Coal Combustion Waste Impoundment
Round 7 - Dam Assessment Report

Lansing Generating Station

Interstate Power and Light Company (IPL)
Lansing, Iowa

Dewberry, LLC
Fairfax, Virginia

LGS - Main Ash Settling Basin Pic #14

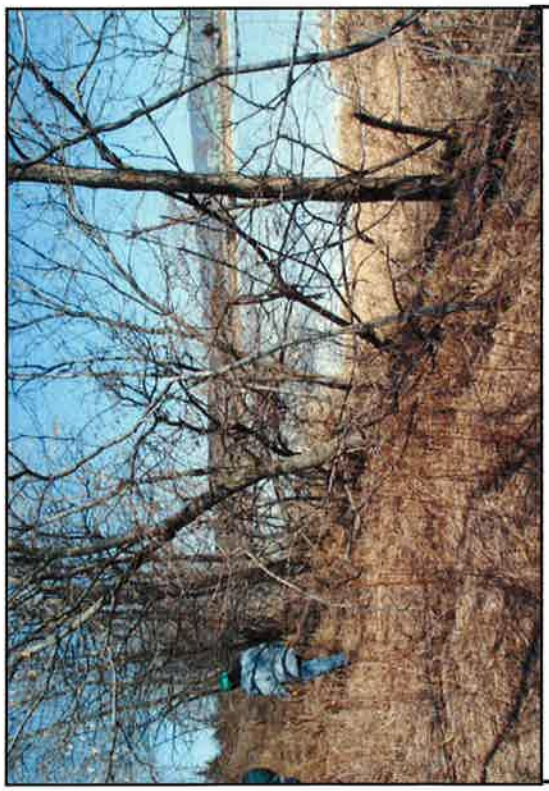
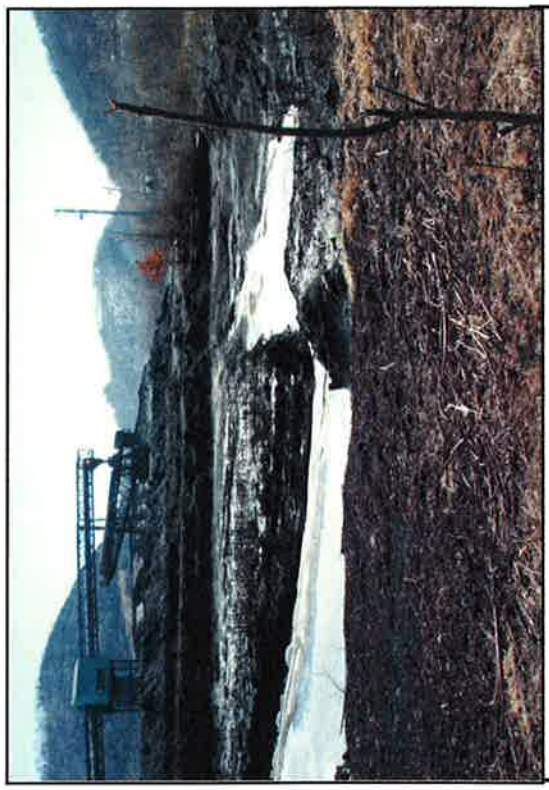
DATE	PHOTO NUMBER	DESCRIPTION of the PHOTO
3/12/2009	LGS Pic #1	No comment
3/12/2009	LGS Pic #2	No comment
3/12/2009	LGS Pic #3	No comment
3/12/2009	LGS Pic #4	No comment
3/12/2009	LGS Pic #5	No comment
3/12/2009	LGS Pic #6	No comment
3/12/2009	LGS Pic #7	Monitor animals activities
3/12/2009	LGS Pic #8	Cut off the trees on the West side of the Main Ash Settling Basin
3/12/2009	LGS Pic #9	Cut off the trees on the West side of the Main Ash Settling Basin
3/12/2009	LGS Pic #10	Cut off the trees on the West side of the Main Ash Settling Basin
3/12/2009	LGS Pic #11	Cut off the trees on the West side of the Main Ash Settling Basin
3/12/2009	LGS Pic #12	Cut off the trees on the West side of the Main Ash Settling Basin
3/12/2009	LGS Pic #13	Cut off the trees on the Northwest side of the Main Ash Settling Basin
3/12/2009	LGS Pic #14	Cut off the trees on the Northwest side of the Main Ash Settling Basin
3/12/2009	LGS Pic #15	Cut off the trees on the Northwest side of the Main Ash Settling Basin
